Re: FortisBC Inc. (FBC)

**Application for a Certificate of Public Convenience and Necessity for Approval
of the Fruitvale Substation Project (Application)**

**Response to the Industrial Customers Group (ICG) Information Request (IR) No.
1**

FRU T1 Load (MW)
2021

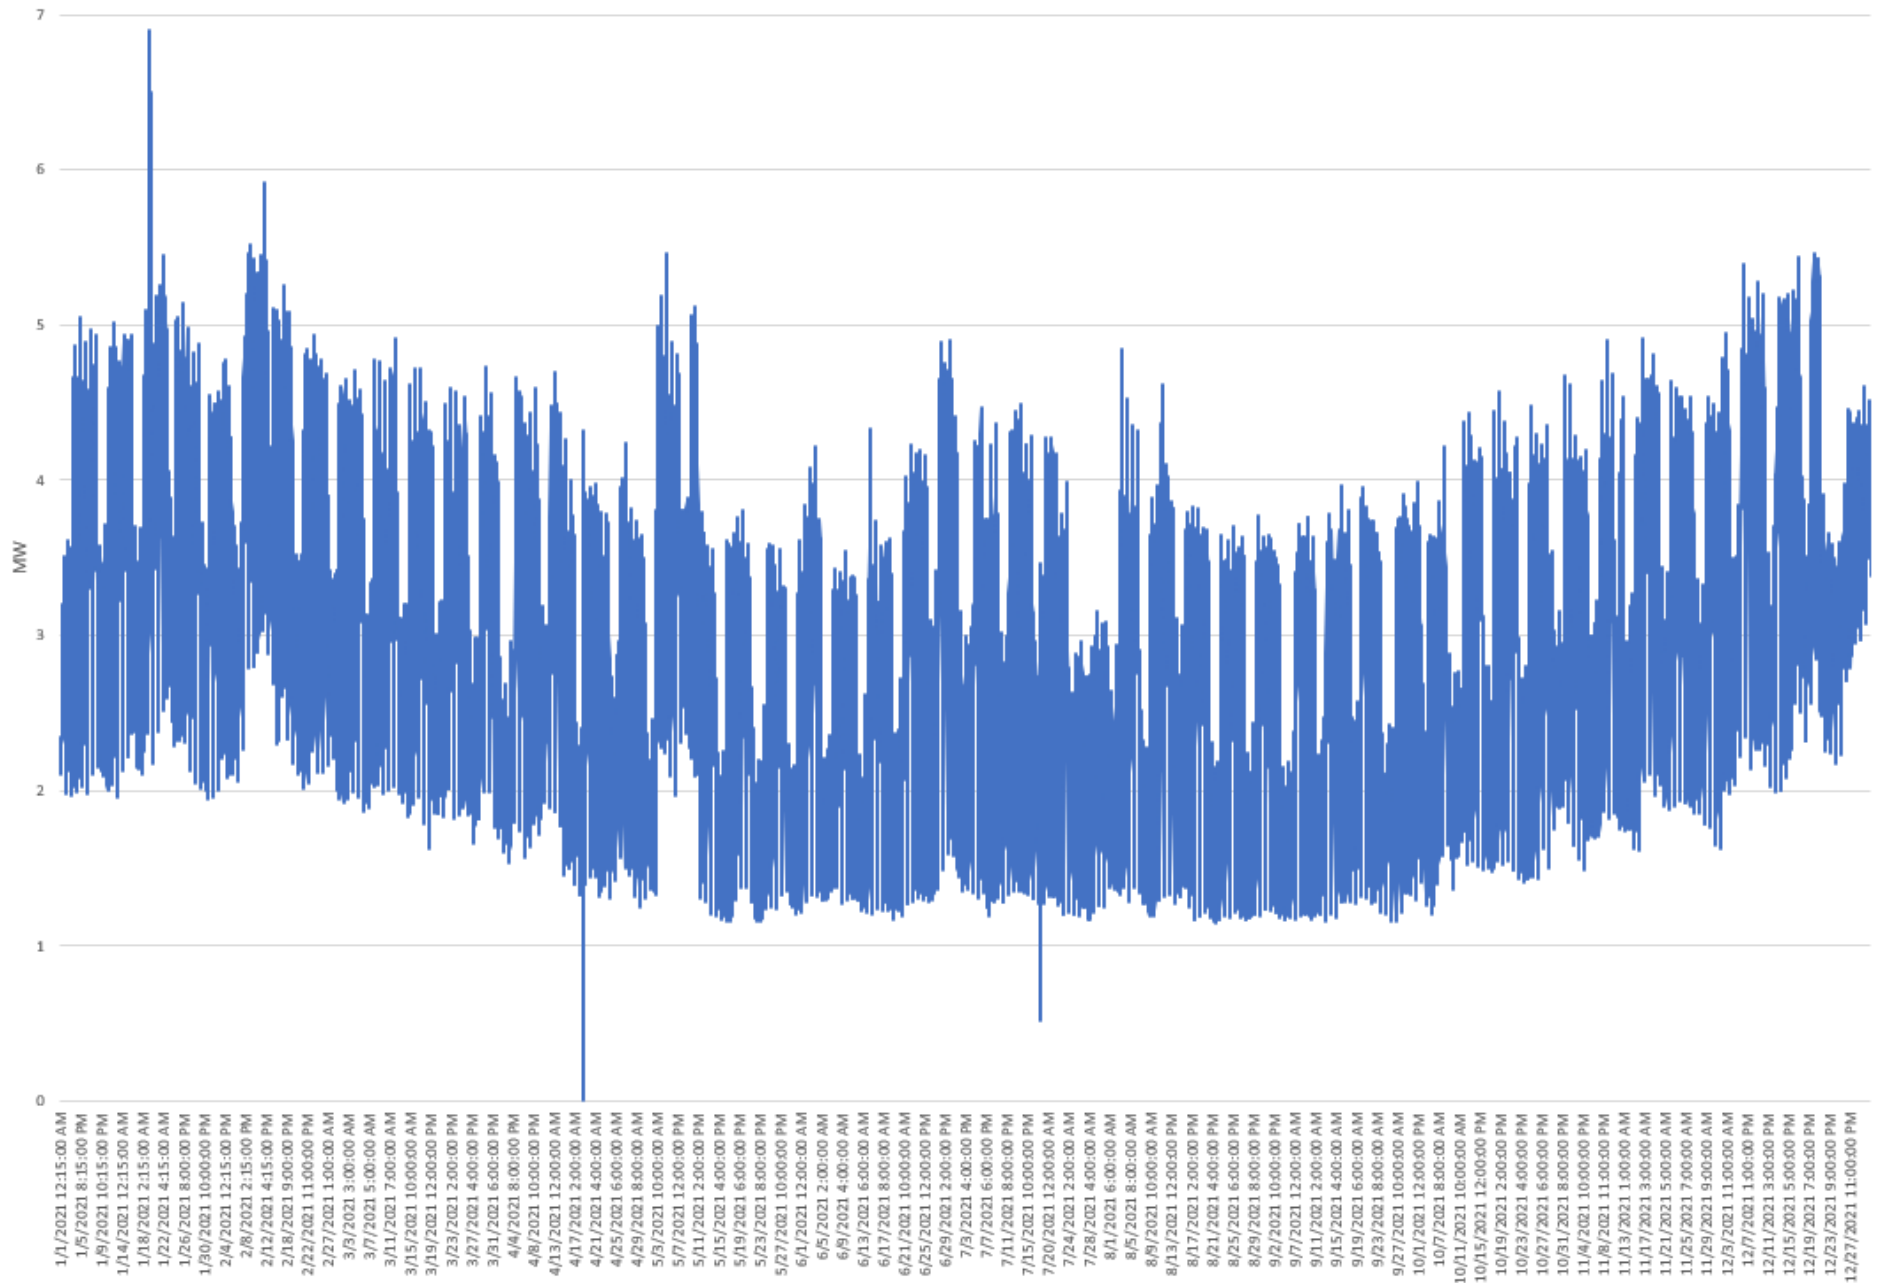
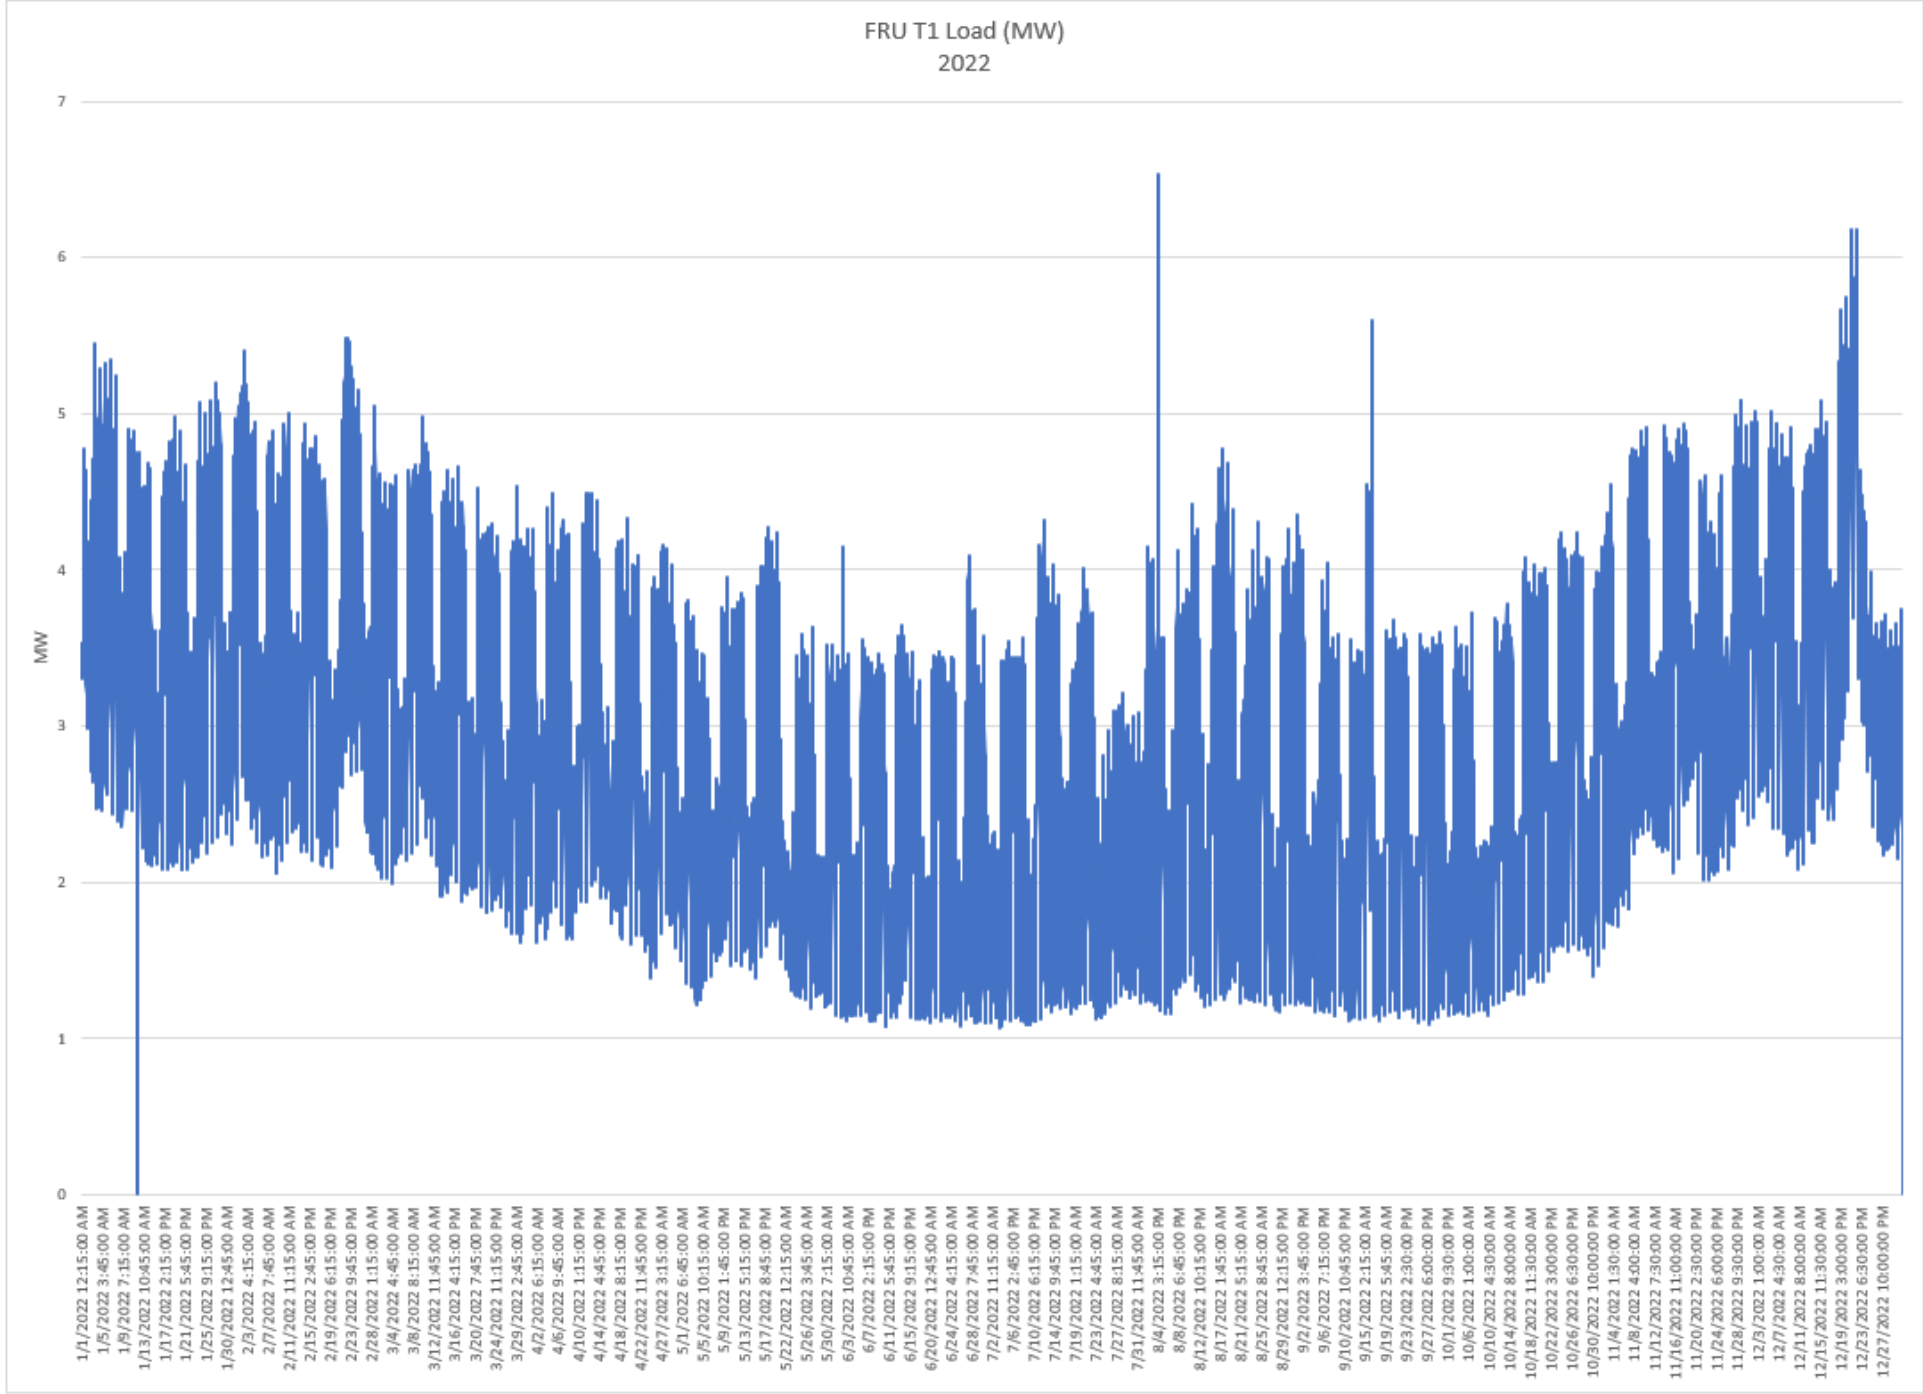
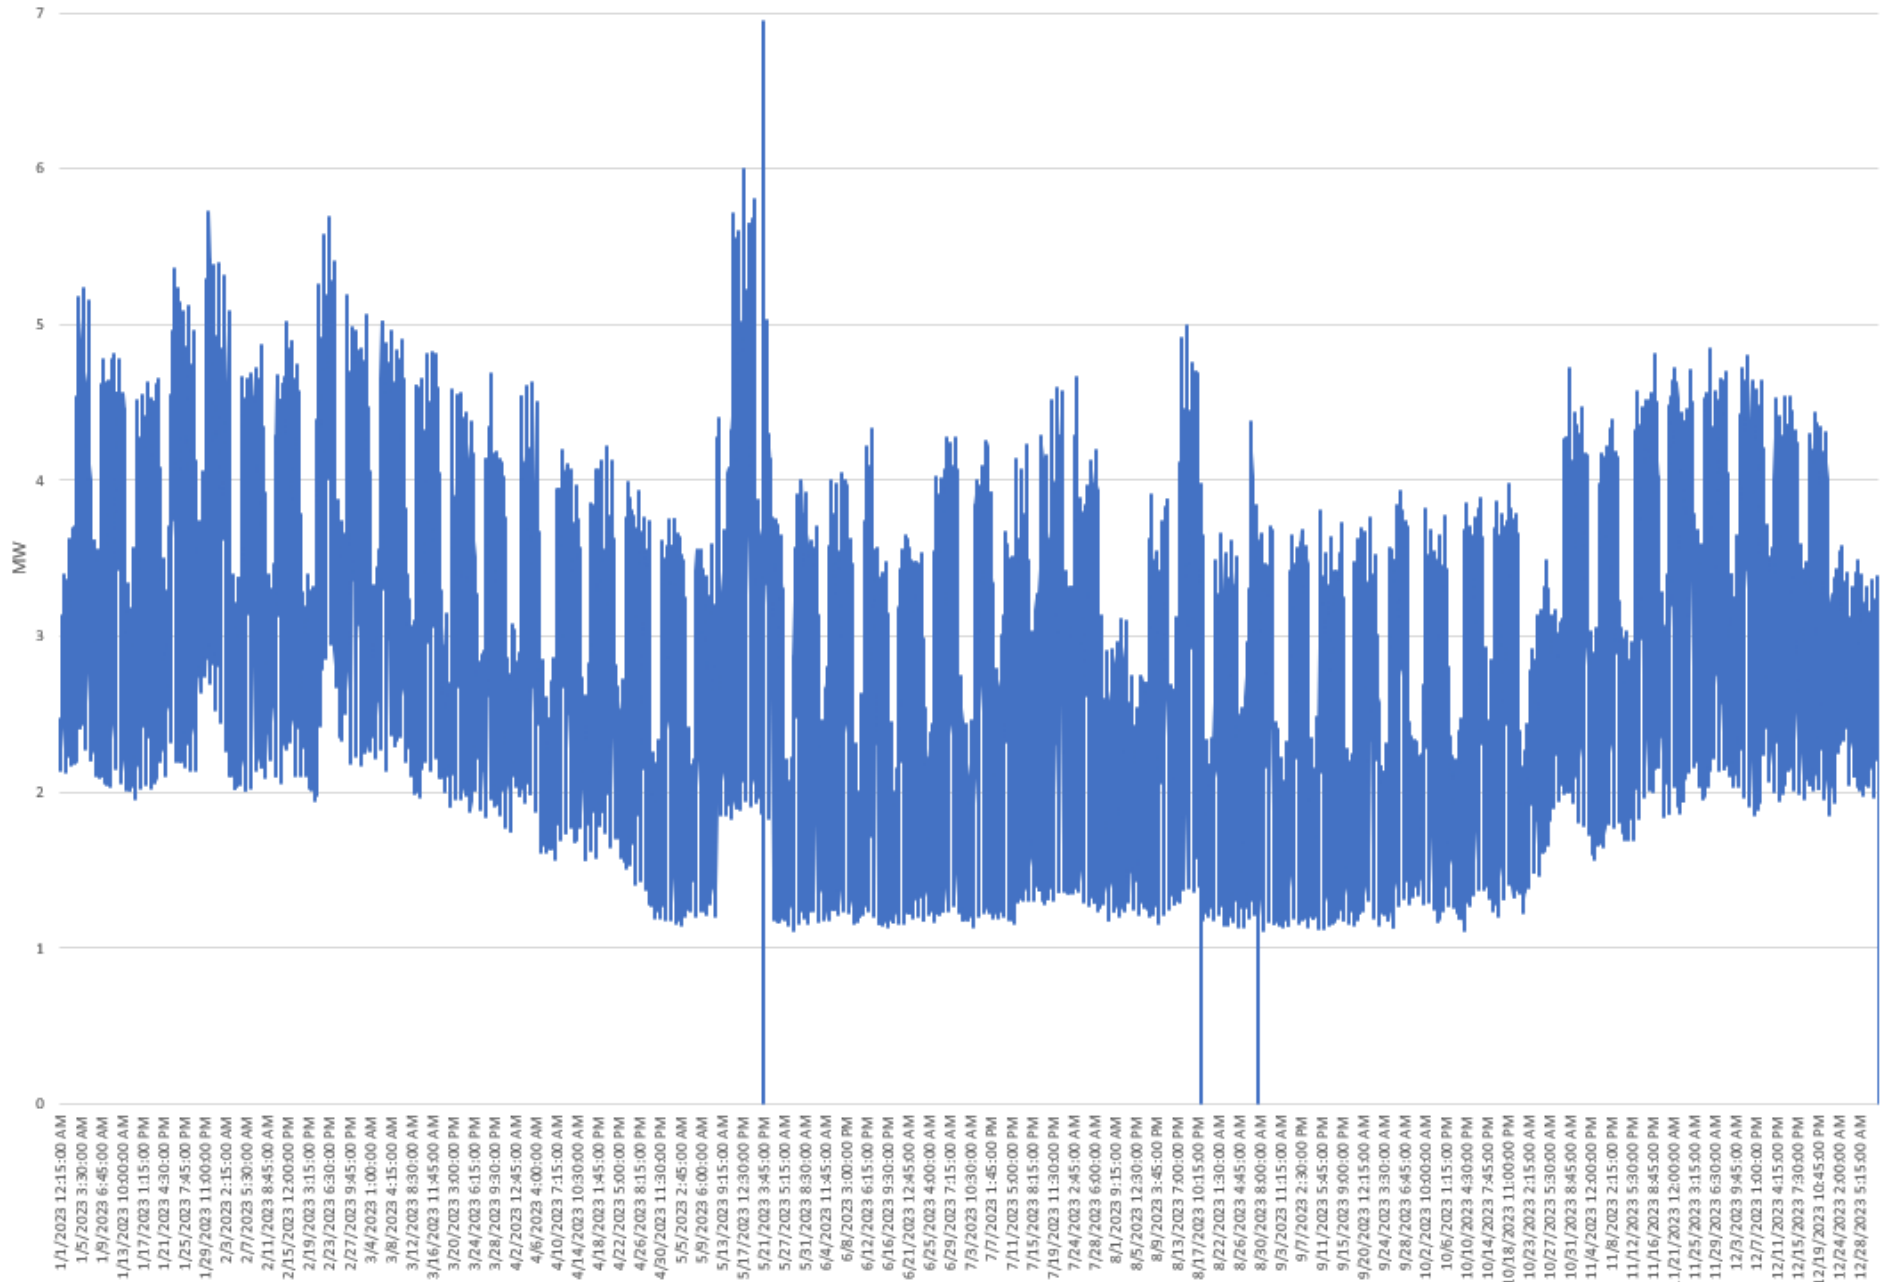
4 1.1 Further to BCUC IR 3.1, please provide a graph and table of the annual peak winter
5 and summer loads served by each of the FRU and HER substations over the last
6 10 years, and specify if any peaks at one station include loads transferred from the
7 other station.

10 FBC provides the requested information in the table below and in Attachment 1.1. FBC notes the
11 following with respect to the information provided:
